IBC MEANS OF EGRESS

Code Change No: **E37-07/08**

Code Change No: **E57-07/08**

Code Change No: E58-07/08

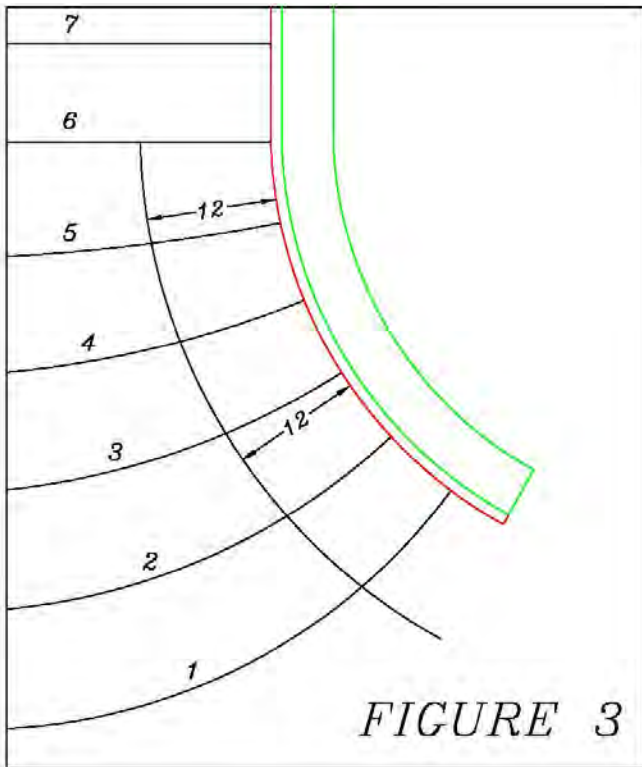
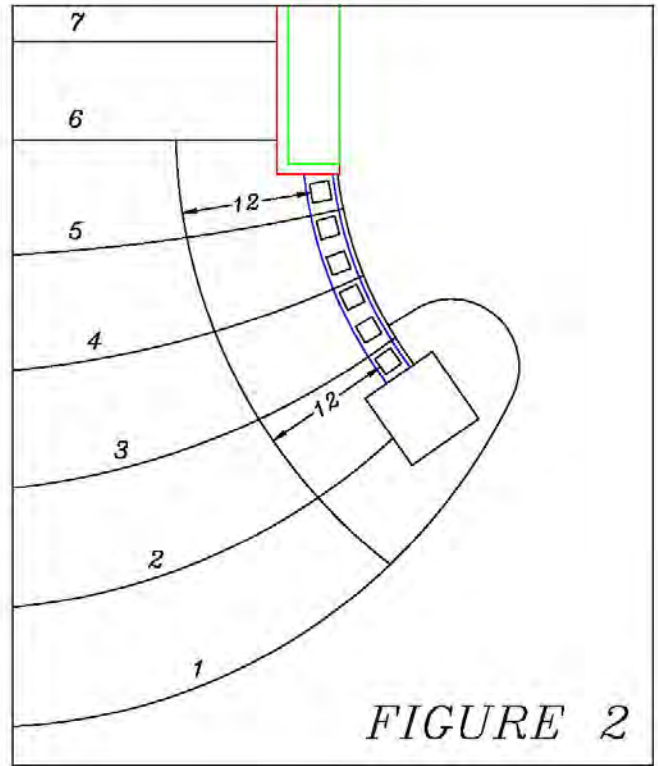
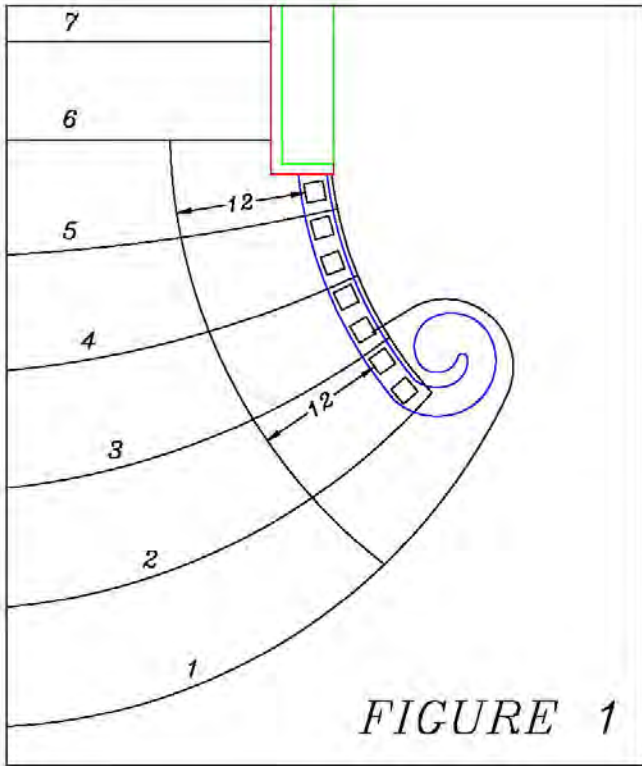
1. Locate the side of the stair where the winder treads are narrower
2. Establish the widest point of clear width of the stair at the surface of the winder or run of adjacent winders
3. Measure across the stair width 12 inches from the object that restricts the clear width at the tread surface
4. Measure tread depth between the intersections of the nosings with the walk line.

Measuring the tread depth at the intersections with the walk line provides for consistent winders that are uniform in depth at the most common path of travel.

The Figures 1, 2 & 3 illustrate common situations in determining the walk line when walls, posts, and balusters/in-fill or combinations of each are located at winder treads. The specification works for any of these situations and assures that the walk line is located as close to the narrow end of the tread as is possible to use. By keeping the walk line closest to the narrow end it assures that the tread is as wide as necessary for safe walking within the width of the stair that is intended and available to use. The 12 inch dimension in the code was determined by measuring the location of a person on a stair while grasping a handrail and is intended to be measured on that portion of the stair that can be used. Portions of winder treads not located within the clear width of the stair do not need to be considered.

Figures 1, 2, & 3 show common walk line locations as determined by the modification. The walk line, balusters, post, and tread nosings are in black. The wall is green and the skirt board or finish stringer is in red.

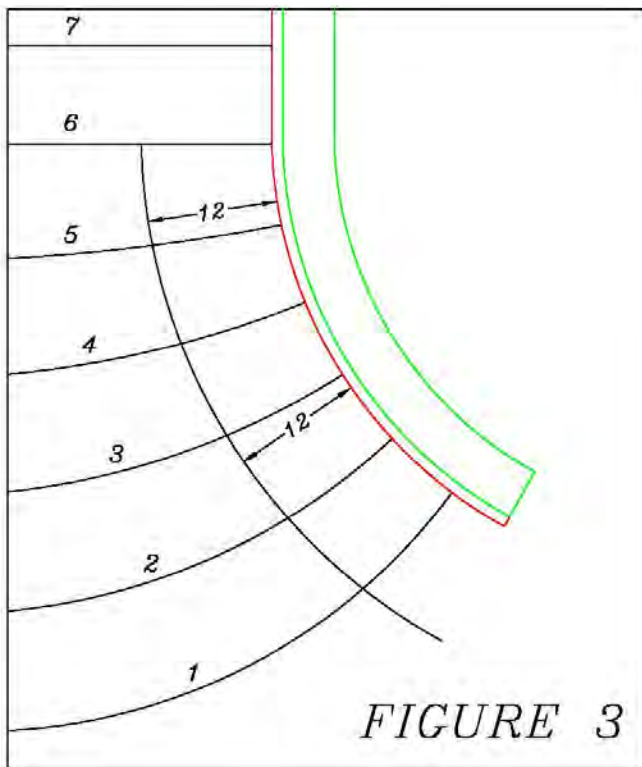
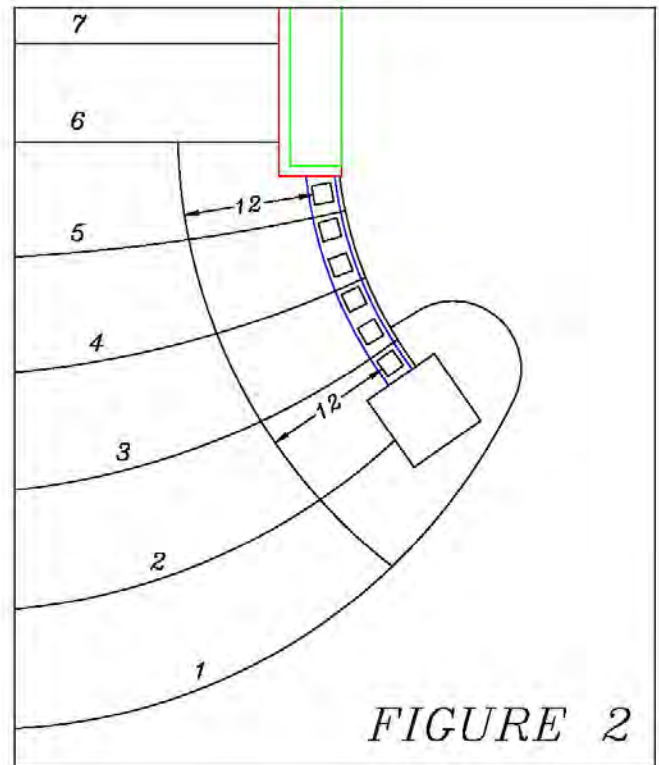
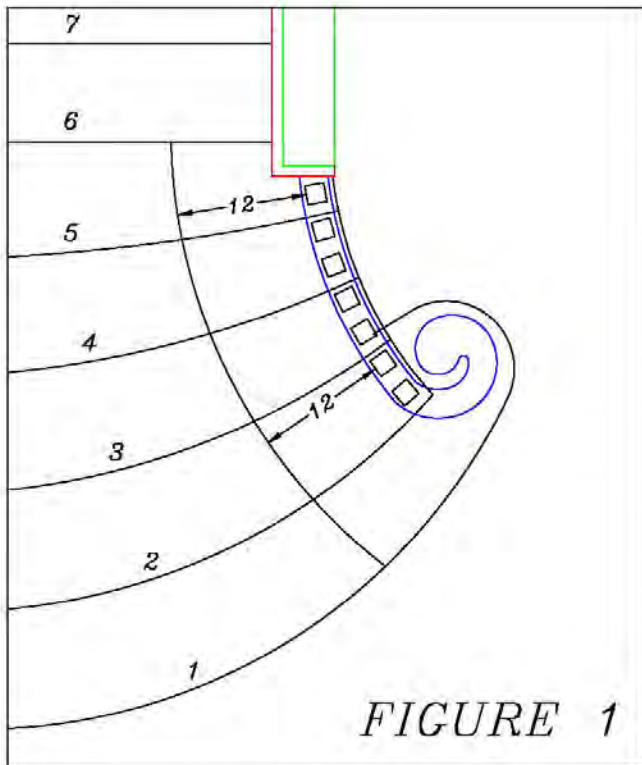
1. Locate the side of the stair where the winder treads are narrower
2. Establish the widest point of clear width of the stair at the surface of the winder or run of adjacent winders
3. Measure across the stair width 12 inches from the object that restricts the clear width at the tread surface
4. Measure tread depth between the intersections of the nosings with the walk line.

Measuring the tread depth at the intersections with the walk line provides for consistent winders that are uniform in depth at the most common path of travel.

The Figures 1, 2 & 3 illustrate common situations in determining the walk line when walls, posts, and balusters/in-fill or combinations of each are located at winder treads. The specification works for any of these situations and assures that the walk line is located as close to the narrow end of the tread as is possible to use. By keeping the walk line closest to the narrow end it assures that the tread is as wide as necessary for safe walking within the width of the stair that is intended and available to use. The 12 inch dimension in the code was determined by measuring the location of a person on a stair while grasping a handrail and is intended to be measured on that portion of the stair that can be used. Portions of winder treads not located within the clear width of the stair do not need to be considered.

Figures 1, 2, & 3 show common walk line locations as determined by the modification. The walk line, balusters, post, and tread nosings are in black. The wall is green and the skirt board or finish stringer is in red.

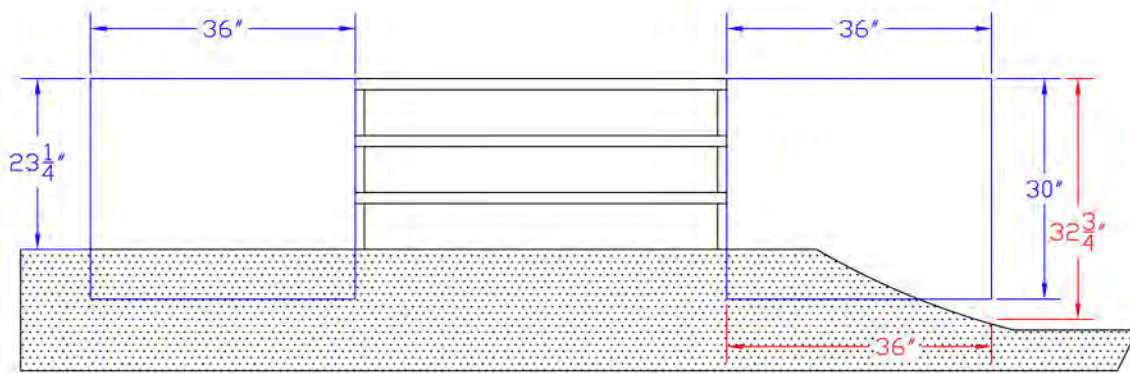
The key part of this change to IBC 1013.1 is submitted in order to clarify how the height measurement which triggers the guard requirement is made relative to proximity to the adjacent fall-off. This is illustrated in the following figure:

The view is taken from the landing of a 3 riser stair, looking towards the face of the risers.
